VIRGINIA ELECTRIC AND POWER COMPANY
NORTH ANNA UNIT NOS. 1 AND 2
GENERAL DESIGN CRITERIA 17 ANALYSIS
UNIT 2 GENERATOR BREAKER INSTALLATION

ATTACHMENT I

NORTH ANNA ONE LINE DIAGRAM
UNIT 2 GENERATOR BREAKER ADDITION

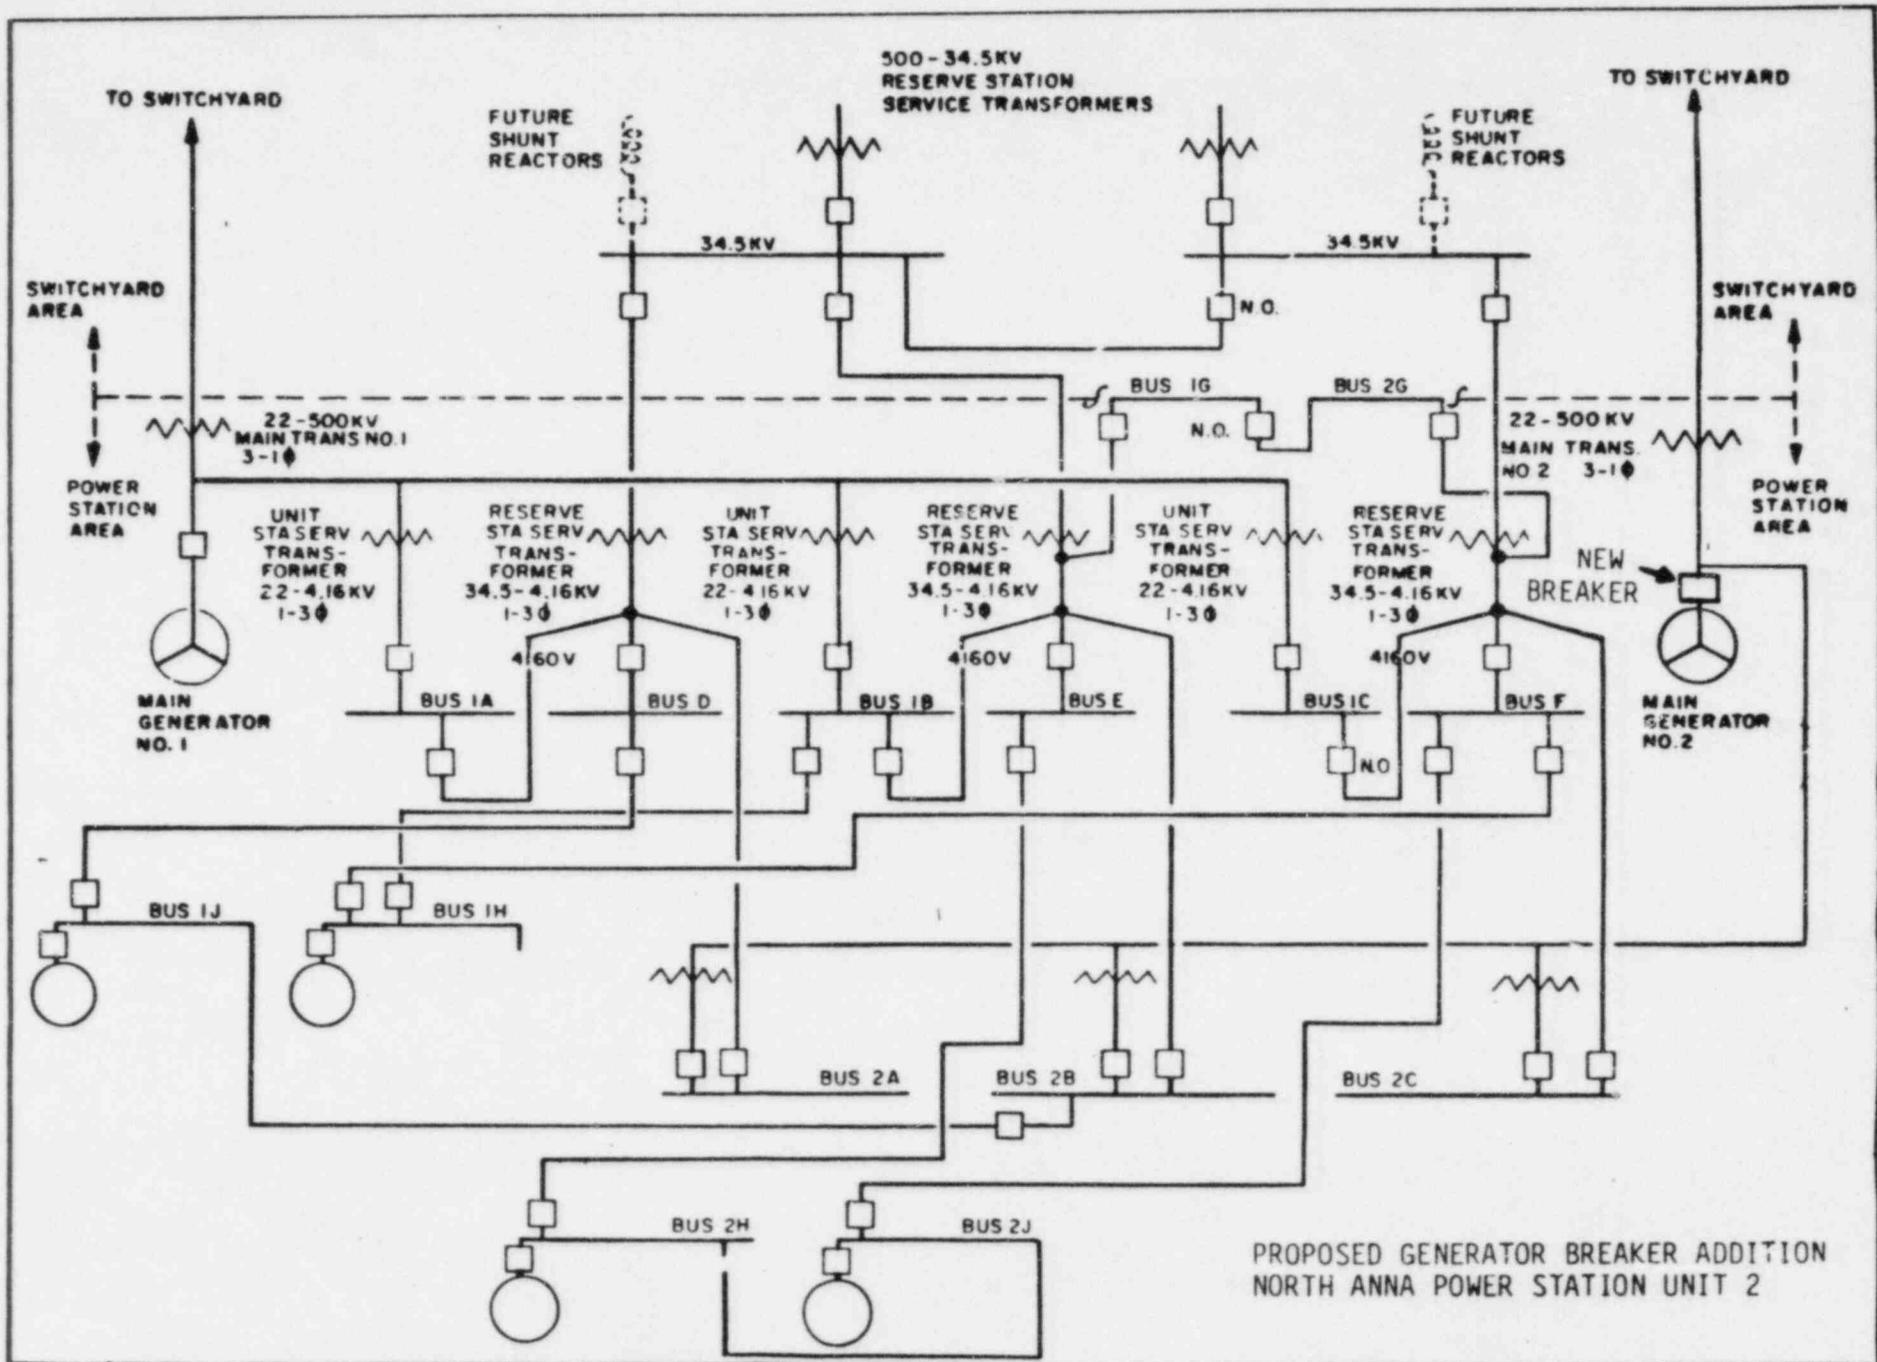
This section is revised to include the Unit 2 generator breaker, which is shown on the one-line diagram in the attached Appendix A. The Unit 2 operation is revised as discussed in Section II: Generator Breaker Installation of this report.
